Access Compliance Report

Public Rights-of-Way

(Curb Ramps)

Intersection ID: 43472	Main Street: S_TRYON_ST	Cross Street: LIONS_MANE_ST	Location: SE
ADA ID: 1000C45C1967	Ramp Type: Perp	Initial Pass/Fail: Fail	Overall Compliance: No
Codes/Mitigation Info/Possible Solution			Severity Score: 25
			Field Measurements/Component Compliance

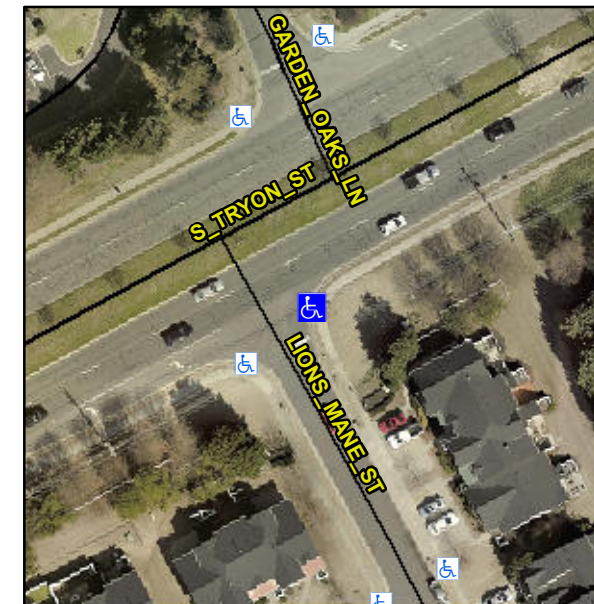
Not Found, R304.2.2, R304.5.3

Compliance	Description	Data	Compliance	Description	Data
N/A	Ramp Length (in)	69.0	No	Ramp Slope (%)	8.8
Yes	Ramp Width (in)	53.0	No	Ramp XSlope (%)	6.8
N/A	Flare Type LT	N/A	N/A	Flare Type RT	N/A
N/A	Flare Slope LT (%)	N/A	N/A	Flare Slope RT (%)	N/A
N/A	Flare Traversable LT?	N/A	N/A	Flare Traversable RT?	N/A
N/A	Landing Length (in)	N/A	N/A	DWS Provided?	N/A
N/A	Landing Width (in)	N/A	N/A	DWS Contrast?	N/A
N/A	Landing Slope (%)	N/A	N/A	DWS Length (in)	N/A
N/A	Landing X Slope (%)	N/A	N/A	DWS Full Width?	N/A
N/A	Landing Curb? (Y/N)	N/A	N/A	DWS Offset (in)	N/A
N/A	Shared Landing?	N/A			
N/A	Gutter Ponding?	N/A	N/A	Gutter Slope (%)	N/A
N/A	Gutter Lip Ht (in)	N/A	N/A	Gutter X Slope (%)	N/A
N/A	Painted X Walk1?	No	N/A	Painted X Walk2?	N/A
	X Walk 1 Direction	To SW		X Walk 2 Direction	N/A
N/A	X Walk 1 Width (in)	N/A	N/A	X Walk 2 Width (in)	N/A
	X Walk 1 Slope (%)	0.3		X Walk 2 Slope (%)	N/A
	X Walk 1 X Slope (%)	5.5		X Walk 2 X Slope (%)	N/A

Remove & Replace Entire Ramp.
